Amphenol Canada Corp - Product Change Notice (PCN)

PCN Date	April 11, 2017
Supplier Name:	Amphenol Canada Corp.
Amphenol Canada PCN Number	PCN-C1295
Description of Change	Change the 2port shield current surface finish from unplated stainless steel shield with tin dipping on PCB tails to shield plated with nickel underplating & selective matte tin plating on PCB tails.
Reason for Change	To improve the consistency of the tin application to grounding tabs
Summary of changes between new and old part	The shield plating and the PCB tails tin dipping feature changed; it does not affect the overall form/fit/ function of the connector.
Traceability guidelines (lot code / date code, markings, ship date...)	The new product will be controlled by date code after confirmed the new sample; Expected to cut in during date code 1724.
Last Time Buy Date	N/A
Datasheet attached? & Filename(s)	RJHSE-538X-02-REVG, RJHSE-538X-A2-REVD
Qual Test data attached? & Filename(s)	TR9240704

Before changed

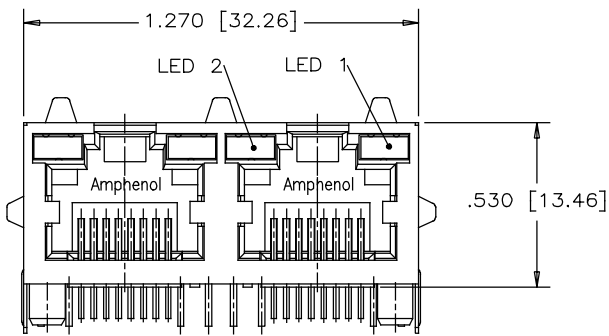
Tin dipping on PCB tails

After changed

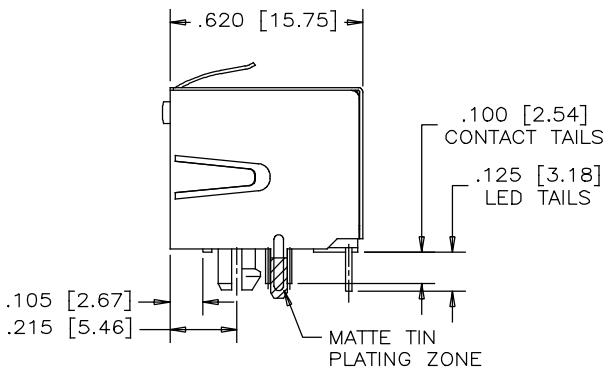
Plated with nickel under-plating
& selective matte tin plating on
PCB tails

PART NUMBER: RJHSE-538X-02

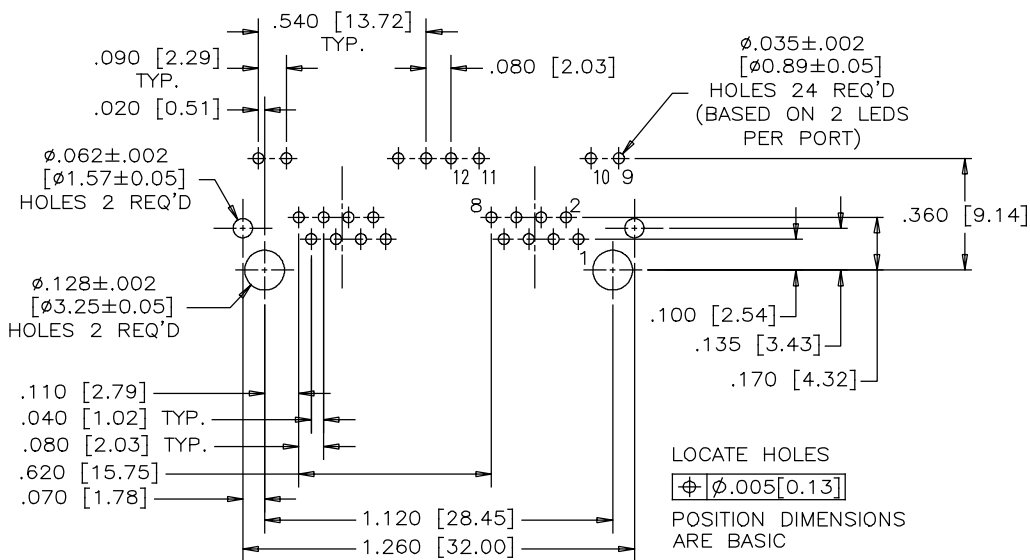
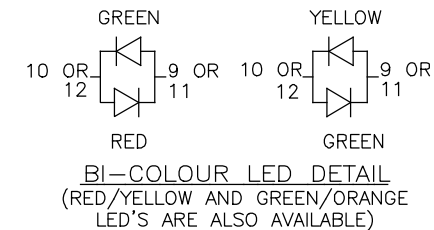
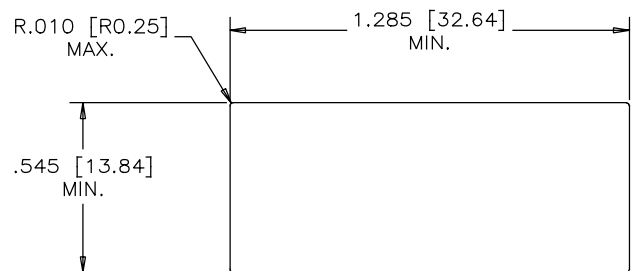
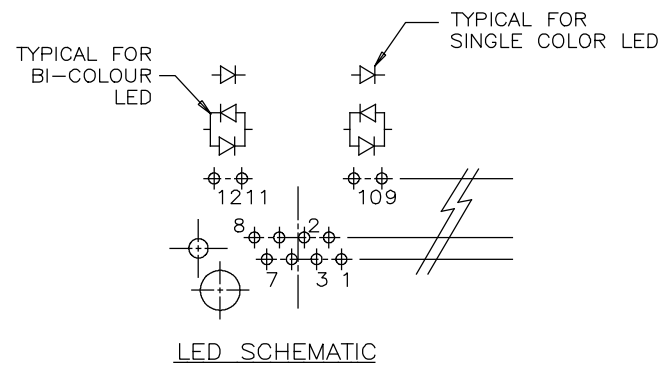
REVISIONS			
REV	DESCRIPTION, ECN, EAR NO.	DATE	APP'D
D	PROPOSAL	MAY 18/06	L.CHAN
E	PROPOSAL	NOV 03/10	L.CHAN
F	CHANGE SHIELD'S MATERIAL PER ECN 160658	JUN 14/16	L.CHAN
G	CHANGE SHIELD'S PCB TAIL PLATING	FEB 22/17	L.CHAN

SHIELD: STAINLESS STEEL WITH MATTE TIN PLATING ON SOLDER TAIL.

PART NUMBER: RJHSE-538X-A2

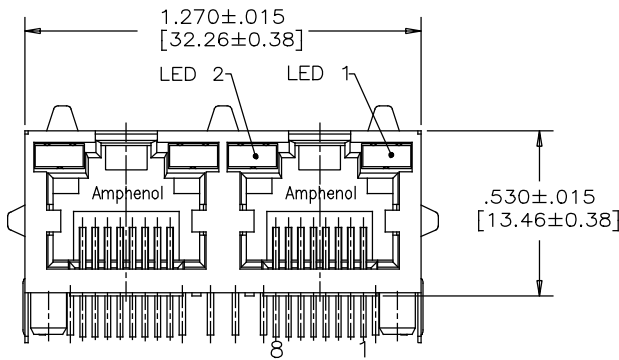
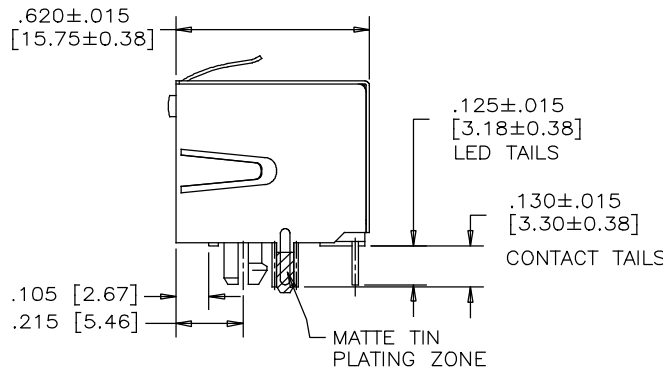
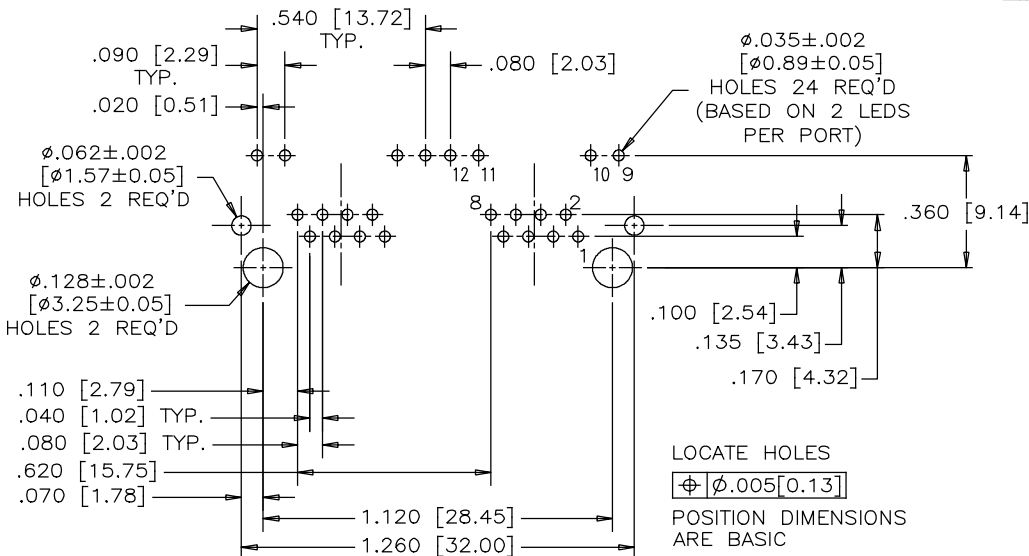
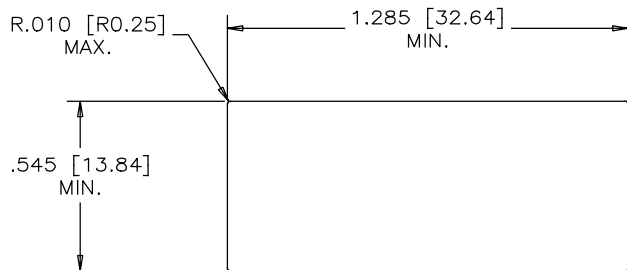
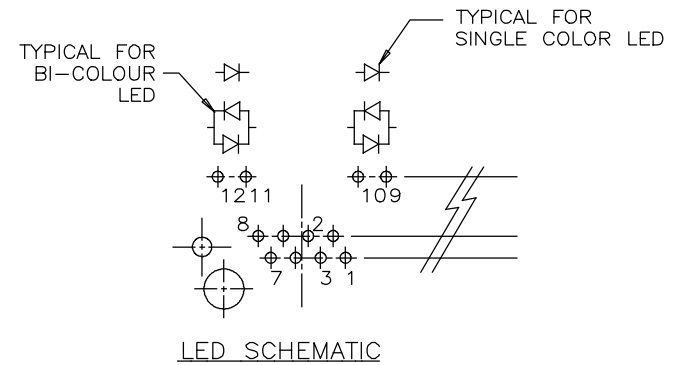
REVISIONS			
REV	DESCRIPTION, ECN, EAR NO.	DATE	APP'D
A	PROPOSAL	DEC 21/06	L.CHAN
B	PROPOSAL	OCT 23/08	L.CHAN
C	CHANGE SHIELD'S MATERIAL PER ECN 160658	JUN 14/16	L.CHAN
D	CHANGE SHIELD PCB TAIL PLATING	APR 12/17	L.CHAN

SHIELD: STAINLESS STEEL WITH MATTE TIN PLATING ON SOLDER TAIL.
